APPEAL SUMMARY

Status: Decision Rendered - Held over from ID 31340 (2/22/23) for additional information

Appeal ID: 31466	Project Address: 1625 NW Johnson St
Hearing Date: 4/12/23	Appellant Name: Erin Ziter
Case No.: B-006	Appellant Phone: 510-292-5399
Appeal Type: Building	Plans Examiner/Inspector: Steven Freeh
Project Type: commercial	Stories: 3 Occupancy: R-3 Construction Type: V-B
Building/Business Name:	Fire Sprinklers: Yes - NFPA 13R, Throughout
Appeal Involves: Reconsideration of appeal	LUR or Permit Application No.: 23-000389-CO
Plan Submitted Option: pdf [File 1]	Proposed use: Residential - Transient Living, R-3 occupancy

5 SECTION LOOKING EAST
A3.0 SCALE 1/8" = 1'-0"

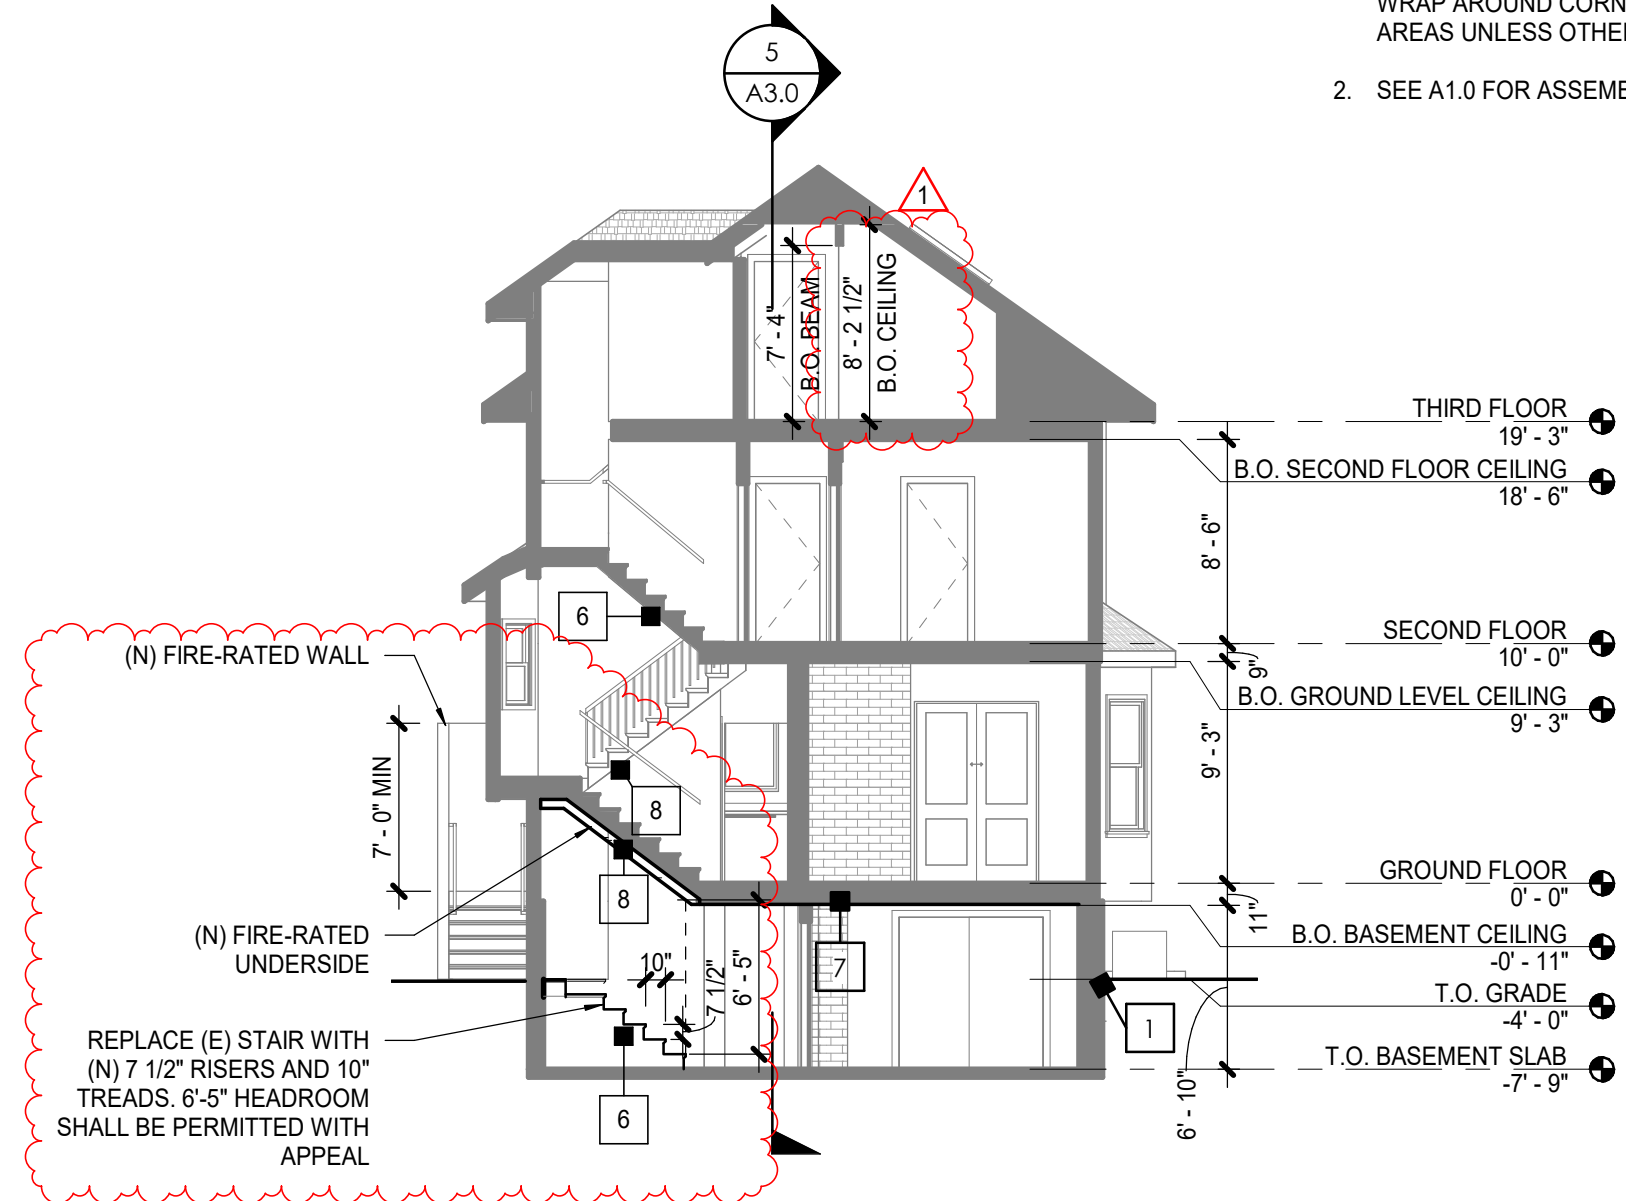
Rather than meet the headroom requirements, and appeal the riser and tread dimensions, we propose to meet the riser and tread dimensions by providing 7 1/2” risers and 10” treads, but the stair shall have a headroom of 6’-5”.

We are proposing to rebuild the existing basement stair with a new stair in the same location. The new stair shall have 10” treads, and 7 1/2” risers, and will have 6’-5” headroom.

Reason for alternative The existing basement stair has a headroom low point of 6’-2”. The existing landing is 33”, the existing treads are 9”, and the existing riser height is 8”. The stair connecting the ground floor to the second floor is directly above the basement stair. The basement stair ceiling has an assumed one layer of gypsum board directly beneath the stair framing. As part of creating a fire-rated separation between the new basement dwelling unit and the upper unit, the basement stair ceiling needs additional layers of gypsum board to achieve a 1 hr fire-rating and STC 50 rating. We are proposing to use a 3 1/2” thick shaft wall assembly to meet these requirements. These additional

layers make the low point of the headroom less than 6'. Therefore, we propose to rebuild the basement stair. By creating a winder tread at the basement entry landing, and rebuilding the treads as 9" deep, and risers 9" tall, we can achieve a headroom of 6'-8" or greater for the entire length of the stairway. The Portland code guide for residential basements (Brochure 9: Converting Attics, Basements, and Garages to Living Space) allows existing stairs to have 9" treads, and allows rebuilt stairs to have 9" risers. The proposed stair is in the only feasible location, and the commercial code requirements of 10" treads, 7 ¾" risers, and a 36" landing is infeasible in this context. Rebuilding and/or relocating the existing stair to meet these standards would pose an undue and unnecessary burden. By rebuilding the stair we have gained headroom to meet the commercial code requirements, and the treads and risers are still within reasonable residential dimensions.

3a. Increase in the maximum allowable stair riser height from 7 inches to 7.5 inches: Granted as proposed.

3b. Decrease in the minimum allowable tread depth from 11 inches to 10 inches: Granted as proposed.

4 NORTH ELEVATION
A3.0 SCALE 1/8" = 1'-0"

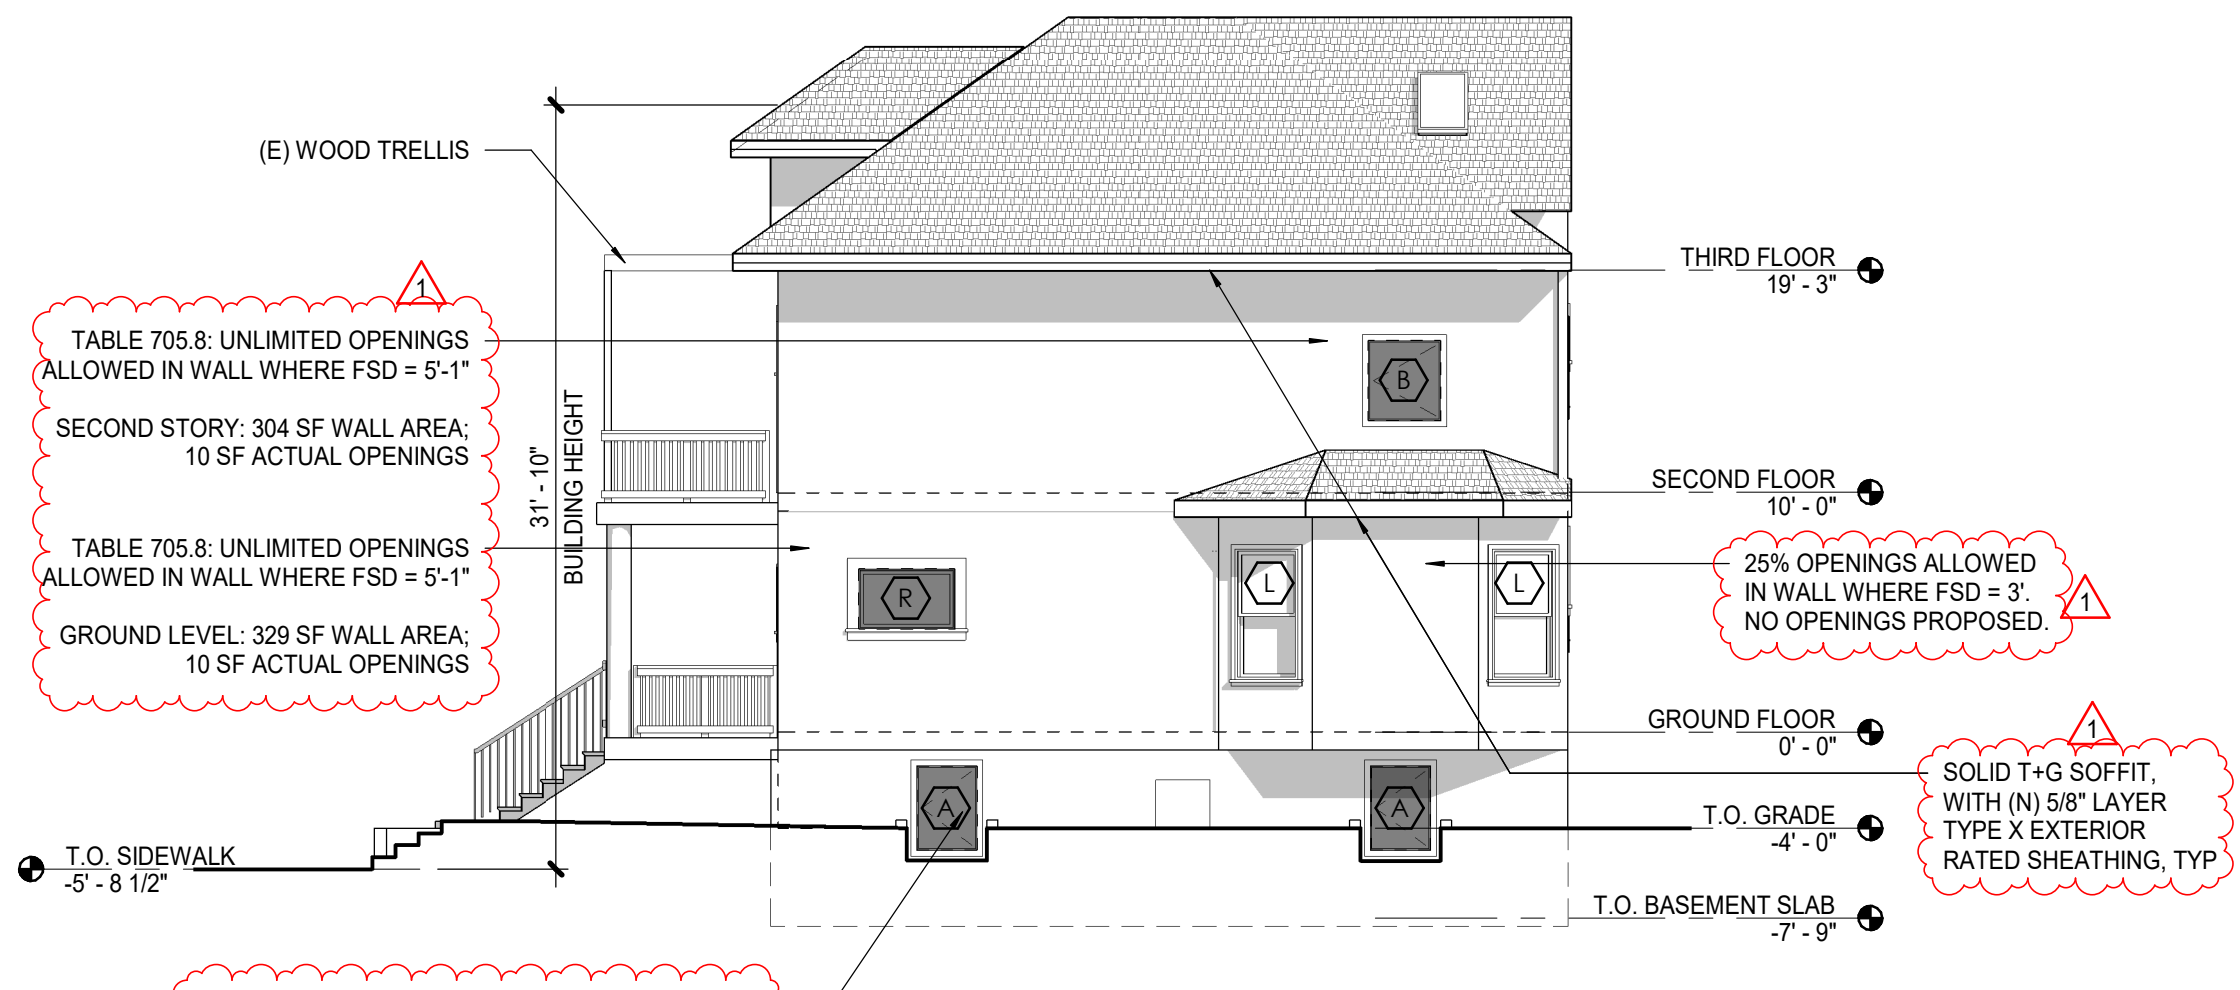
Code Modification or Alternate Requested We are requesting the type VB roof eaves within 5' of the east and west property lines to remain as-is as unrated construction. We are requesting to exceed the allowable unprotected openings in north wall.

We are proposing to apply one layer of exterior rated 5/8" sheathing to the type VB roof eaves within 5' of the east and west property lines. We are requesting to exceed the allowable unprotected openings in north wall.

The existing roof eaves on the east and west walls will have one layer of 5/8" exterior rated sheathing applied to the undersides. The north wall has existing openings on the ground level

(11%), second level (8.6%), and attic level (29.7%). We are proposing all existing openings remain, but where there are operable windows, they shall be swapped out with non-operable windows. There shall be no egress to the north. Other alterations include: installing a new NFPA 13R sprinkler system throughout the house, providing a 1-hr rated separation between the two dwelling units, and protecting the rear exterior stair with 1-hr rated wall construction. Additional sprinkler heads can be placed at the north wall openings if the appeal board deems this necessary and acceptable.

The 13R sprinklers will provide a greater level of safety to the openings in the north wall. All operable windows in the north wall shall be removed.

2b. Increase in the maximum allowable area of unprotected exterior North wall openings from not allowed to 11 percent on 1st Floor, 9 percent on 2nd Floor and 30 percent on 3rd floor. Granted as proposed.
